SAFETY EVALUATION REPORT
SOURCE AND BYPRODUCT MATERIAL LICENSE
KERR-MCGEE NUCLEAR CORPORATION
SOUTH POWDER RIVER BASIN
"Q" SAND PROJECT

DOCKET NO. 40-8768

LICENSE NO. SUA-1387

May 31, 1981

FIGURE 3-4

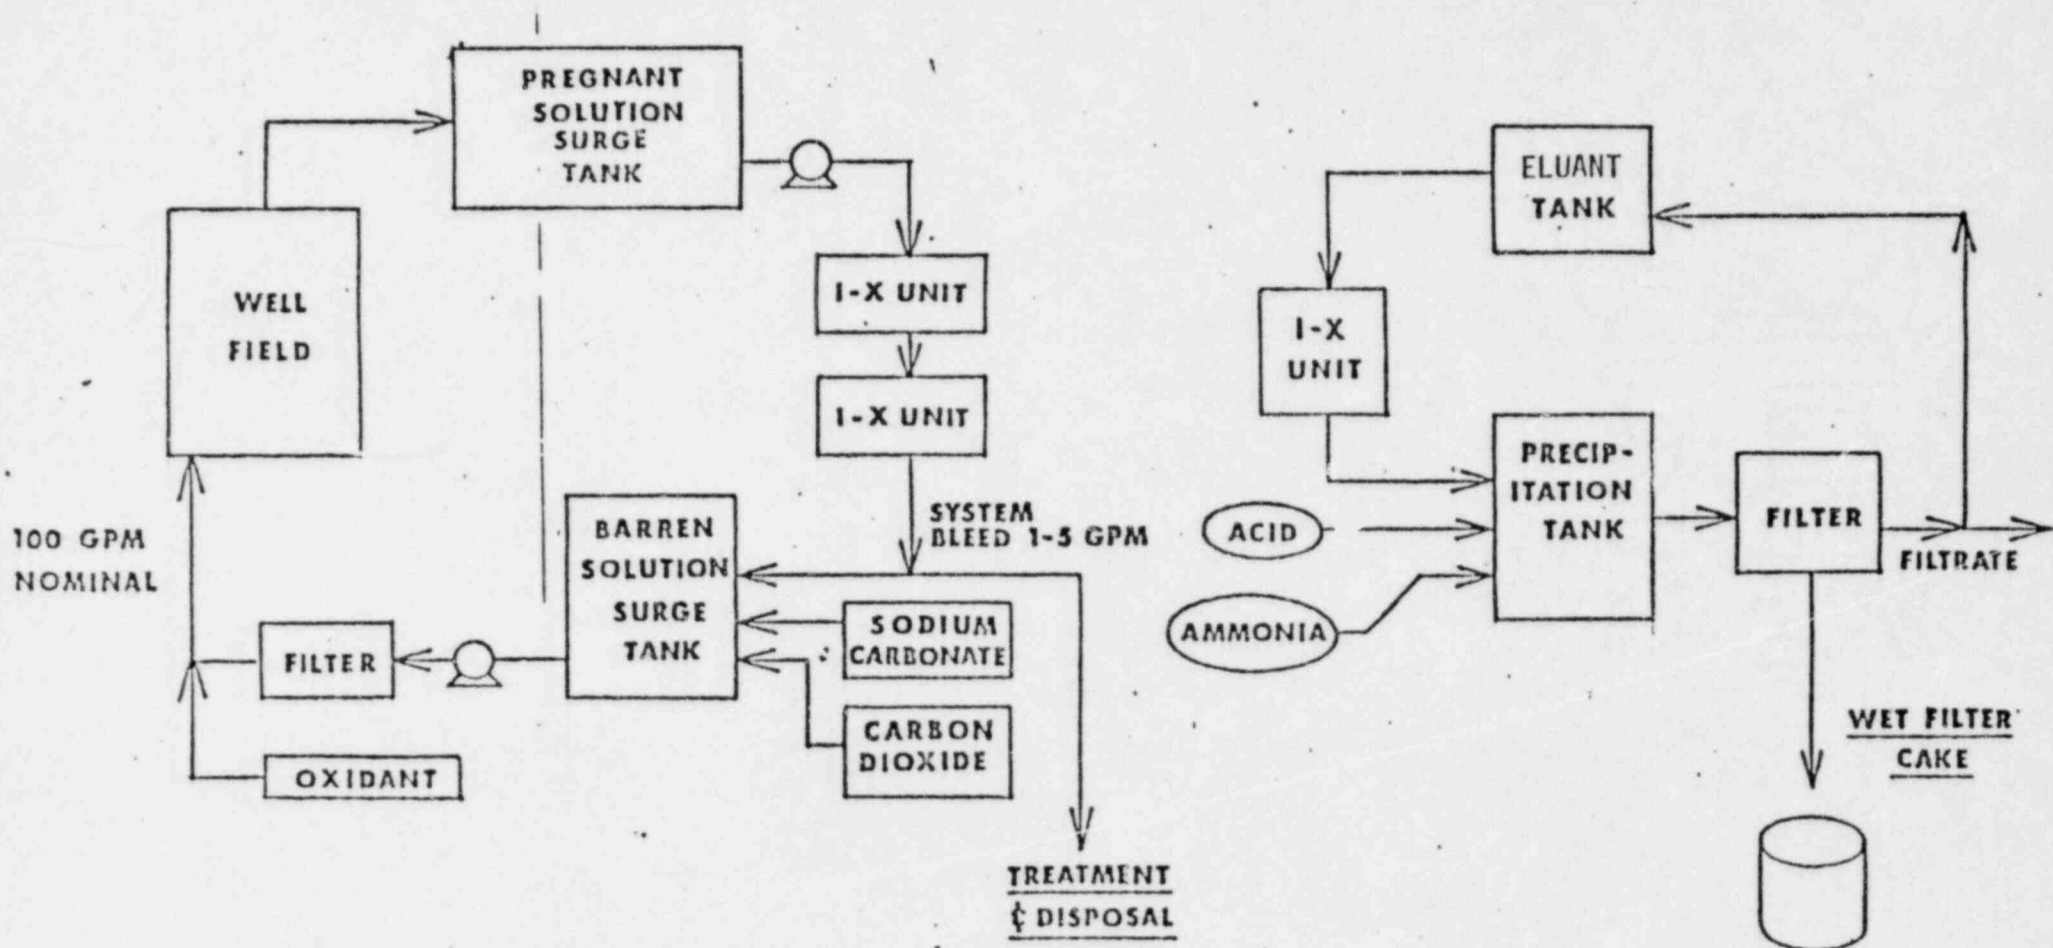
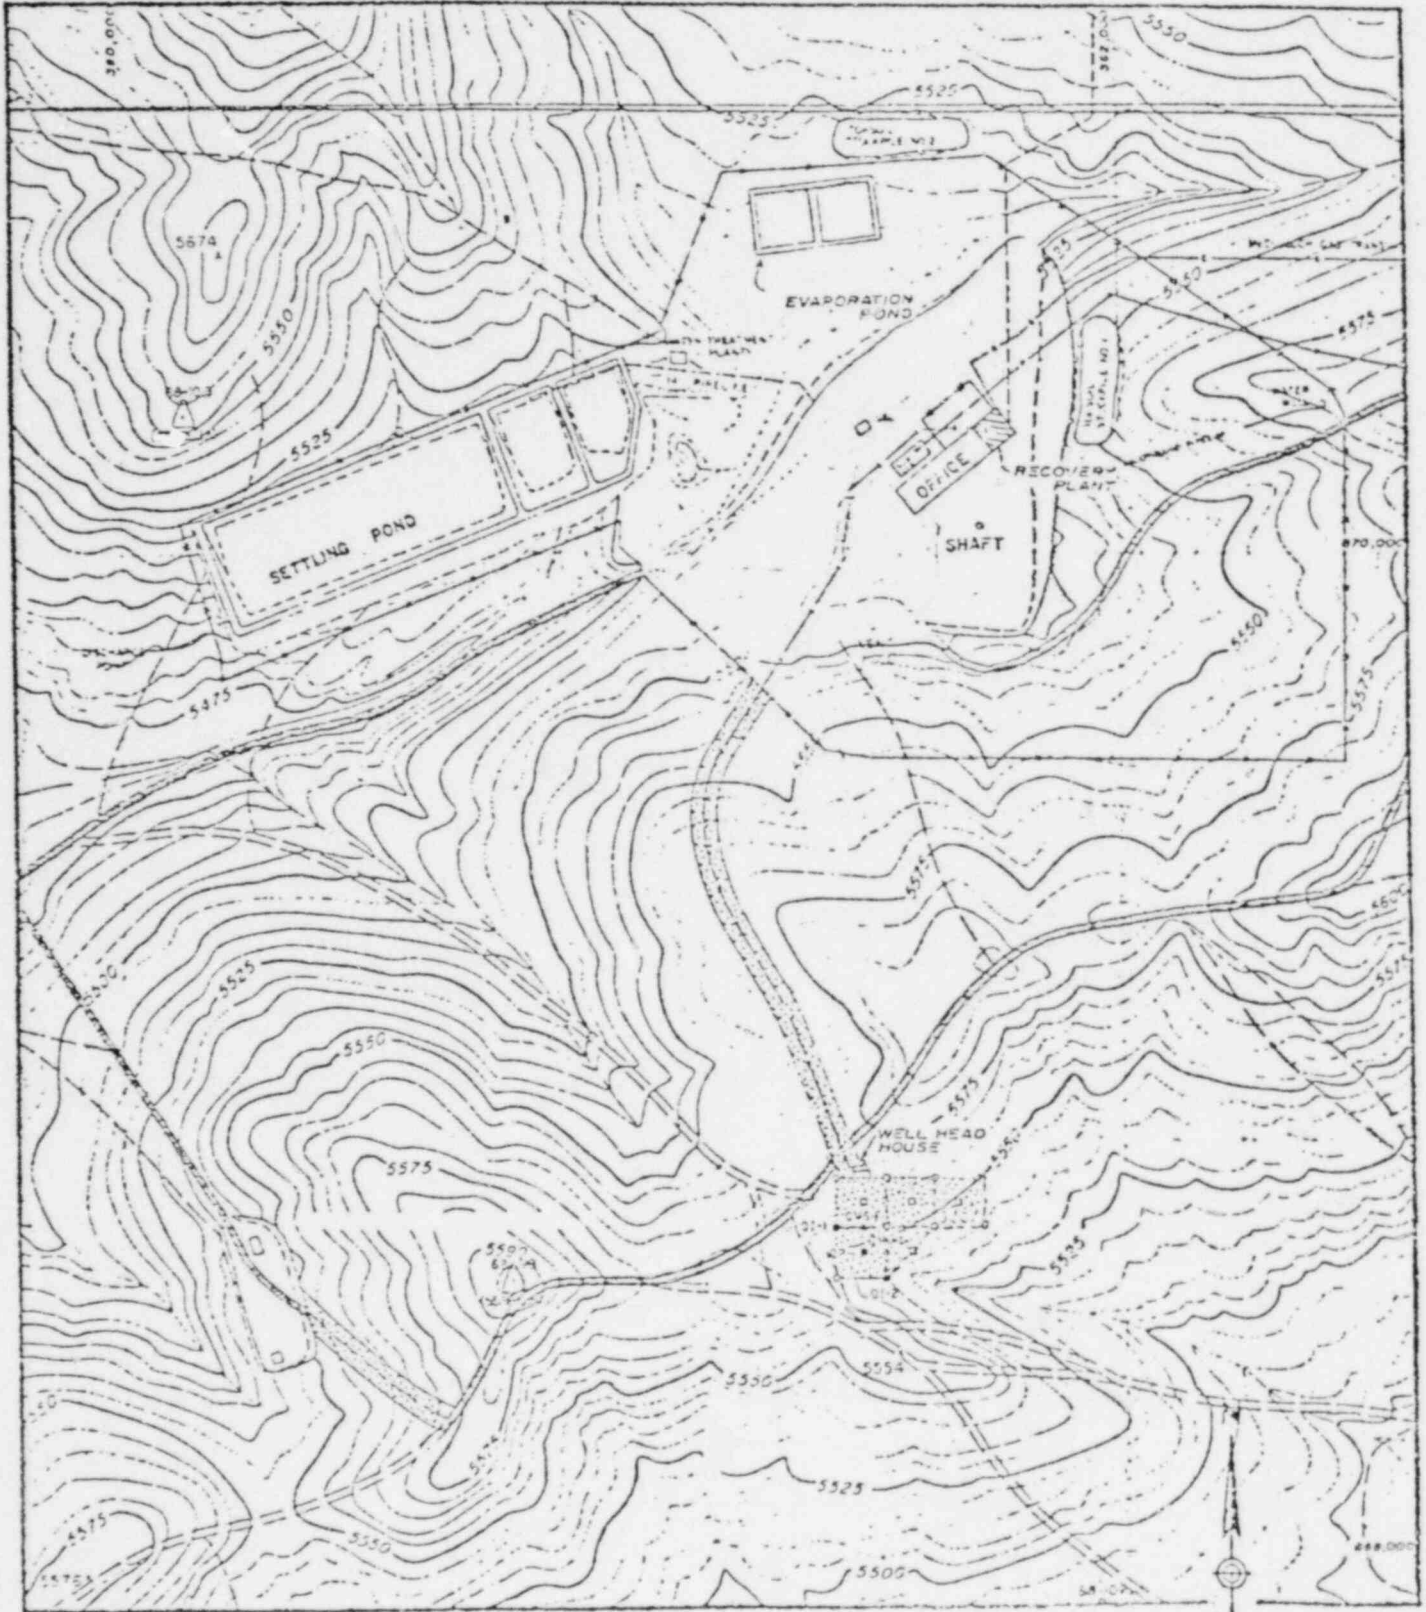
24. Any changes in the process circuit, illustrated and described in Figure 3-4 of the license application dated March 25, 1980, shall require the approval of the RSO and shall be submitted to the U.S. Nuclear Regulatory Commission, Uranium Recovery Licensing Branch, for prior approval in the form of a license amendment.

POOR ORIGINAL FIGURE 3-2

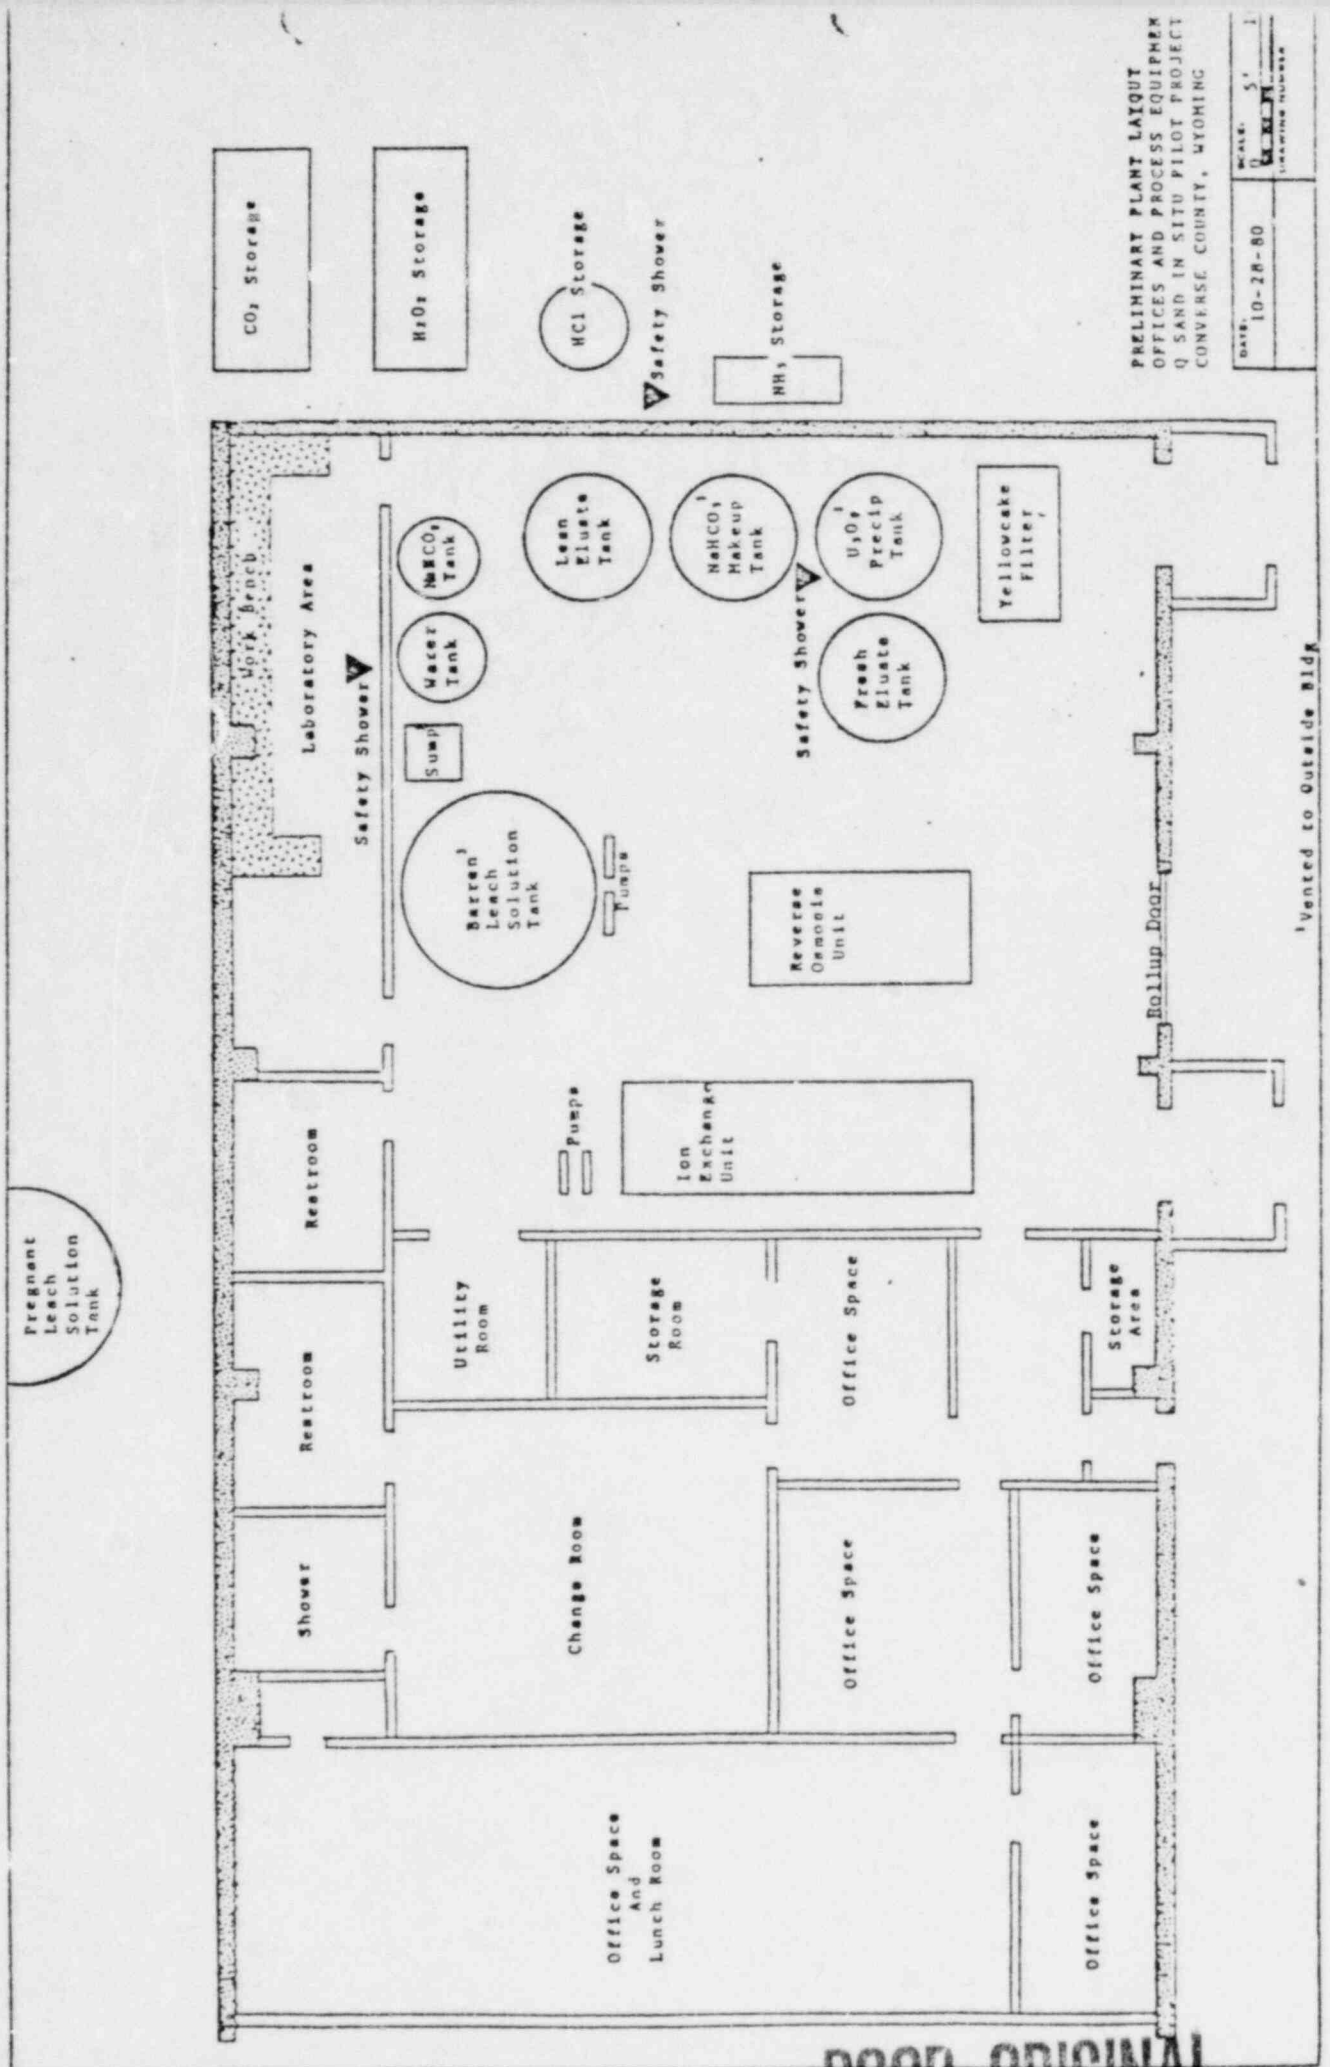
The applicant provided a facility floor diagram, as Attachment 4 to submittal dated December 5, 1980, showing the proposed layout for process equipment, offices, the laboratory, and worker change and eating areas. The proposed layout would require that process workers pass through office areas of the facility to enter the change room or showers. In addition, the laboratory staff would be required to pass through the process areas of the facility to go from the office area to the laboratory.

The staff has concluded that the applicants proposed floor layout design could reasonably lead to the spread of contamination to nonprocess areas such as the office areas and the laboratory. The staff requires that the applicant shall modify the facility layout design to provide for better traffic patterns from process areas to nonprocess areas. The staff will require that eating shall only be allowed in administrative offices, in enclosed lunch areas, and in control rooms that are separated from the process areas. The staff believes the applicant should provide access to the process area through the change room rather than through office areas. Also, applicant should see if access to the laboratory area from the change area can be made without passage through the process area. Prior to commencement of operations, the applicant shall be required to submit the revised layout for NRC review and approval.

28. The licensee shall modify the facility layout design submitted as Attachment 4 to letter dated December 5, 1980, to provide for better traffic patterns from process areas to nonprocess areas. Access to the process area should be provided through the change room rather than through office areas. Within thirty (30) days of the issuance of this license, the revised floor plan and a description of the changes made shall be submitted to the Uranium Recovery
